COUNCIL SUBMISSION

NOTICE OF EXHIBITION – BAPTISTCARE CARLINGFORD SENIORS HOUSING (SSD-33631237) AT 1 MARTINS LANE & 3A HOMELANDS AVENUE, CARLINGFORD

ATTACHMENT 1 – DETAILED RESPONSE

Figure 2 Swept Path for Loading Dock

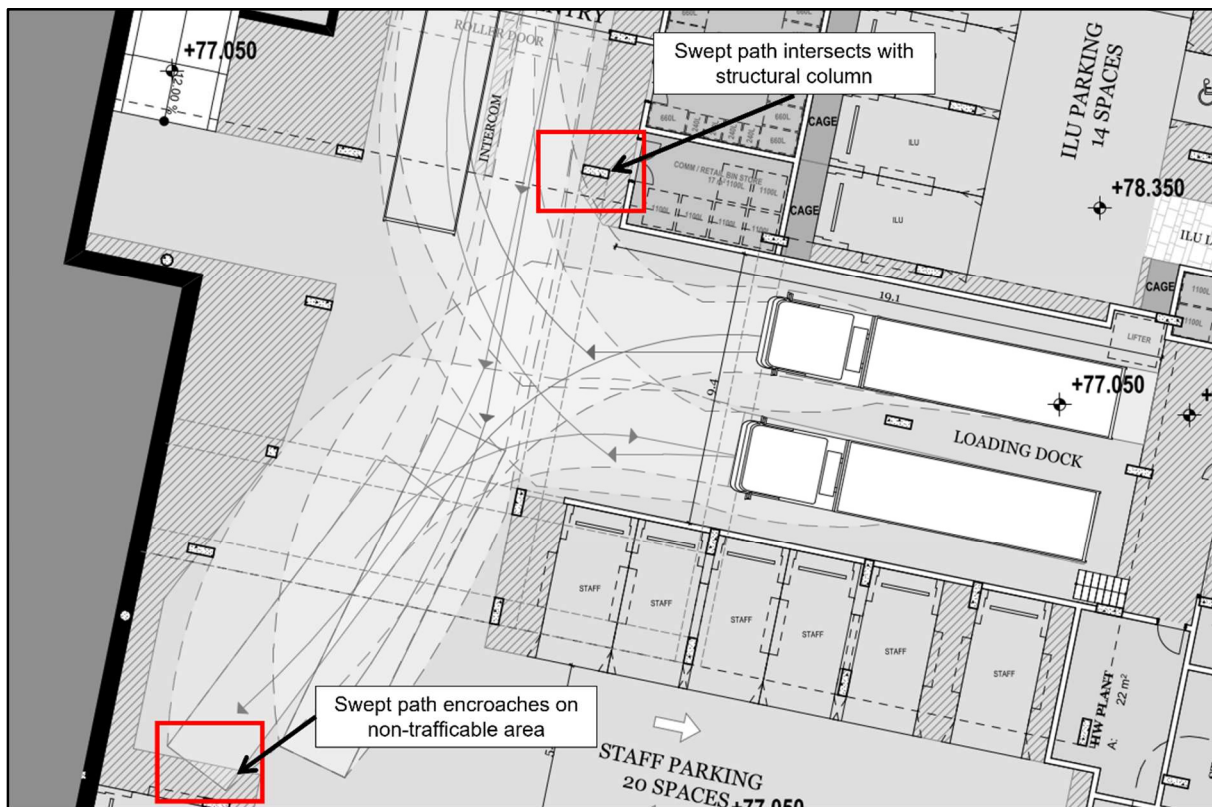
Minimal swept path testing has been provided by the proponent demonstrating that light and heavy vehicles can effectively navigate the several basement levels within the proposed development. Swept path testing has been partially provided for the main loading dock area – however, the swept path testing provided demonstrates insufficient room within the basement level for heavy vehicles to perform three-point turns (see diagram below).

The proposed location and configuration of the main loading dock is considered a poor planning outcome and is not supported. The existing location and configuration of the main loading dock requires heavy vehicles to perform a three-point turn and blocks access to the main staff parking area. In addition, it is considered that there is insufficient space within the basement level to enable heavy rigid vehicles to successfully navigate corners and trafficable areas without obstructing other carriageways.

It is also requested that swept path testing be provided for the secondary loading bay on Basement Level 2.

It is considered that there is ample space at the Subject Site to accommodate a loading dock with direct (or near direct) access to the street. It is recommended that the proposal be redesigned to site the loading dock further to the east and away from the main parking area of the development. The redesigned loading dock should be supported with thorough swept path testing that demonstrates that heavy rigid vehicles can enter and exit the site in a forward direction.

Figure 3 Deep soil zone calculations

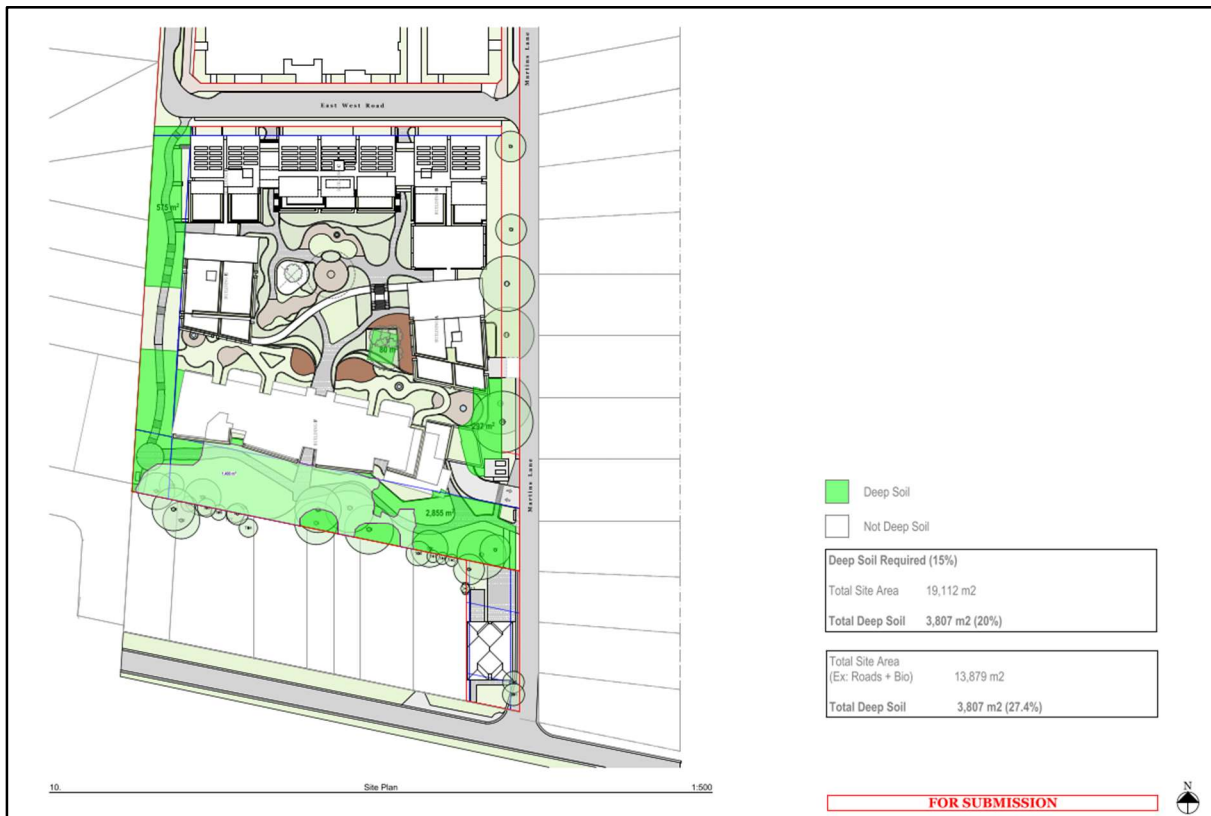
The Application's accompanying architectural drawings include deep soil zone calculations which supports the proponent's claim that the proposed development would provide a total of 3,807sqm of deep soil landscaping (see figure below). This equates to a total of 20% of the site area.

However, the deep soil zone calculations provided by the proponent do not accord with the statutory definition of **deep soil zone** and **landscaped area** under the *State Environmental Planning Policy (Housing) 2021*. The relevant definitions are as follows.

The deep soil zone calculations provided by the proponent include areas with built improvements both above and below ground including pathways, substations, courtyards, stormwater infrastructure (including drainage pipes), and basement structures. In addition, parts of the identified deep soil zone include areas with dimensions of less than 3m, which is inconsistent with the requirements of cl. 108(2)(f) of the *State Environmental Planning Policy (Housing) 2021*. An overview of areas to be excluded from deep soil zone calculations is provided below.

The total area to be excluded from deep soil calculations as shown in Figure 6 is estimated at approximately 723.7sqm. The true deep soil zone provided within the proposed development is therefore around 3,083.3sqm or 16% of the total site area. It is noted that the excluded areas in Figure 6 do not include areas where stormwater drainage pipes are located. As such, the proposal is likely to provide less than the minimum 15% deep soil area as required under the Housing SEPP.

Council requests that the proposal be redesigned to enhance deep soil landscaping within the site and decrease the quantity of impermeable surfaces.

Figure 5 Southern Elevation (Building F)

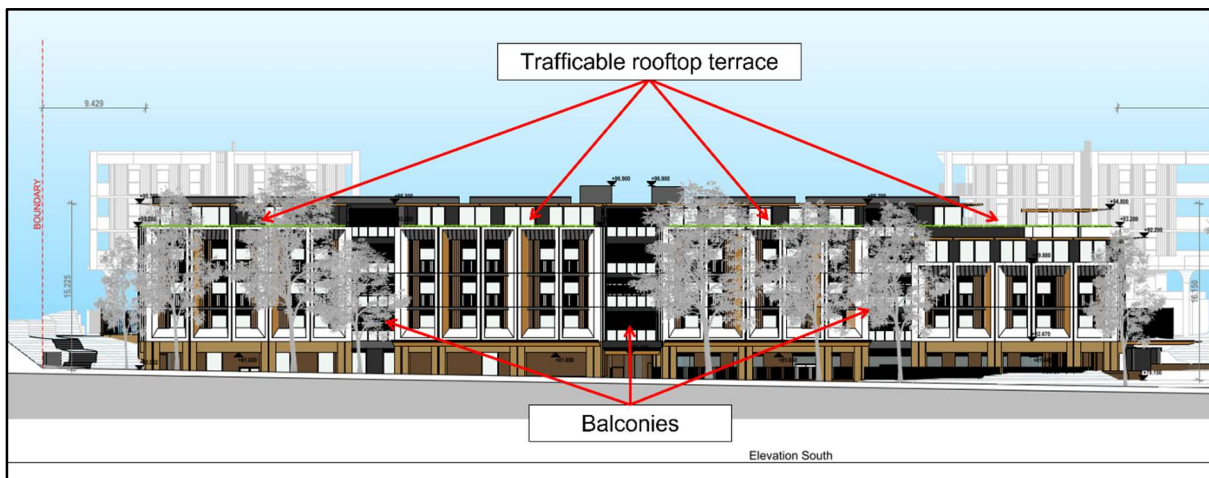
The proposed residential aged care facility (Building F) includes a proliferation of habitable rooms, balconies, and trafficable rooftop terraces with a southern orientation (see elevation diagram below).

The provision of southern-oriented habitable areas within the development would facilitate direct overlooking opportunities into the principal private open space of multiple dwelling houses on Homelands Avenue (see figure below). No privacy measures have been incorporated into the design of the proposal to mitigate potential visual privacy impacts.

Existing vegetation along the southern boundary of the site may partially obscure overlooking opportunities from the proposed development. However, the sole reliance on vegetation and landscaping to mitigate visual privacy impacts is inconsistent with the planning principle established in *Super Studio v Waverley* [2004] NSWLEC 91 at paragraph 6.

Council requests that the proponent incorporate fixed privacy screening measures along the southern elevation of Building F to protect the visual privacy of adjoining residents if a reduced setback is maintained.

Figure 7 Required Turning Circle

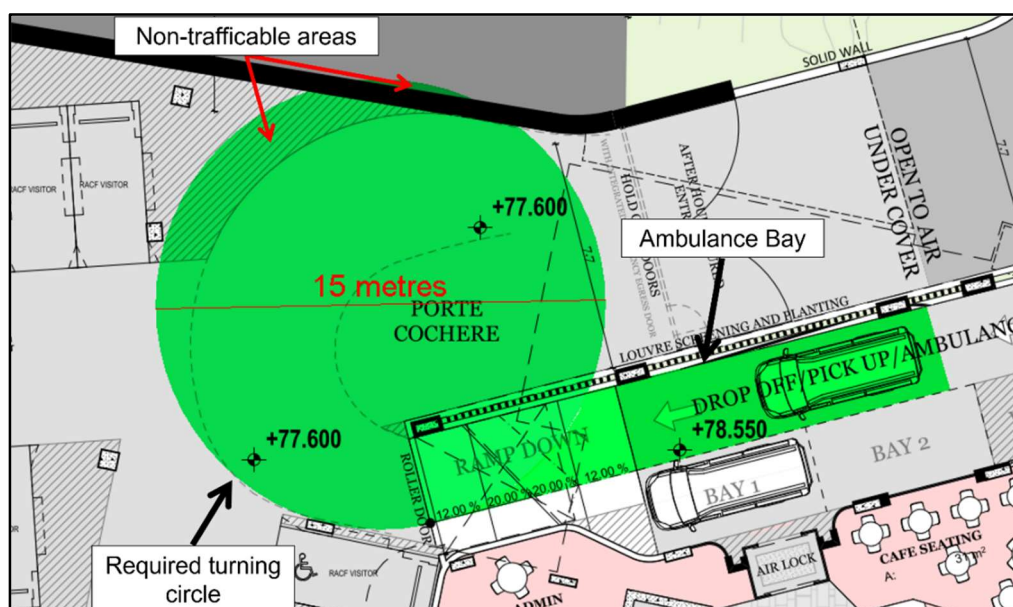
The proposed Porte Cochere does not include a turning circle with a minimum diameter of 15m as illustrated in the following diagram.

In addition, the configuration of the Porte Cochere requires ambulances (and other vehicles) to travel through two (2) security roller doors in order to leave the site. The requirement to travel through two roller doors is inconsistent with Ambulance NSW requirements to provide unimpeded access to buildings.

It is requested that the Porte Cochere and ambulance bay be redesigned to accord with the requirements of Ambulance NSW.

Figure 8 Commercial/retail bin store

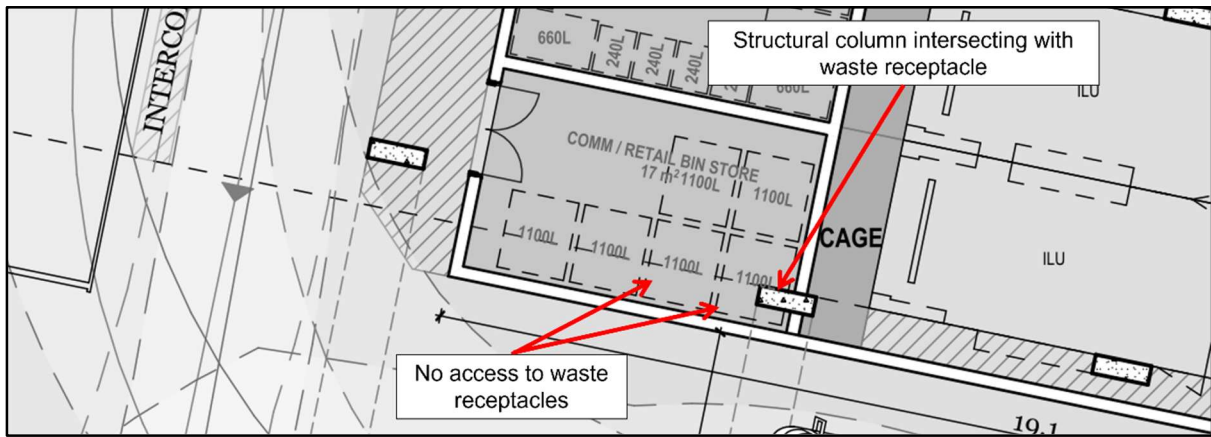
The 'commercial/retail bin store' on the ground level is proposed to accommodate a total of six (6) 1,100L bins. However, the configuration of the storeroom prevents user access to bins located at the rear of the room as illustrated in the following figure. In addition, there appears to be insufficient room within the storage area to accommodate the required bins due to the presence of a structural column.

Council requests that the proponent amend the architectural drawings to include sufficient space within waste storage areas to allow user access to all required waste receptacles. In addition, Council requests that clear, unobstructed paths of travel be provided away from trafficable areas to prevent user conflict within the development. A consolidated waste storage area adjacent to the loading dock should also be provided, in lieu of the nine (9) bin rooms proposed throughout Basement Level 1 and Basement Level 2. Finally, Council requests that the bulky waste storage room located on Basement Level 2 be relocated to the loading dock area.

Figure 9 Potential path of travel for waste collection

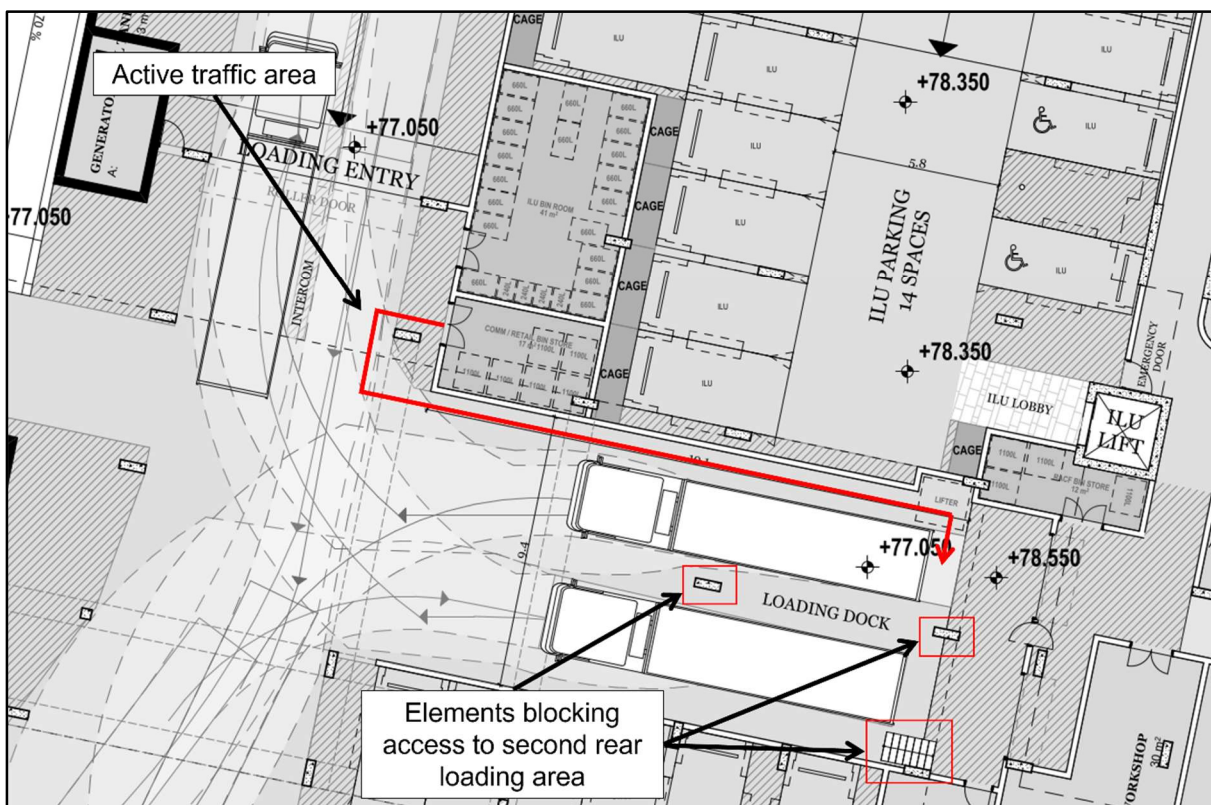
The Application's accompanying waste management plan does not provide detailed paths of travel from the multiple waste storage area to the waste collection point within the primary loading dock. A preliminary review of the layout of the basement level and primary loading dock reveals that there is insufficient room to navigate the waste receptacles to the rear of the loading dock for collection (see figure below). The presence of structural columns within the basement level also requires users to move waste receptacles through vehicular lanes and trafficable areas, potentially creating conflict between users of the development.
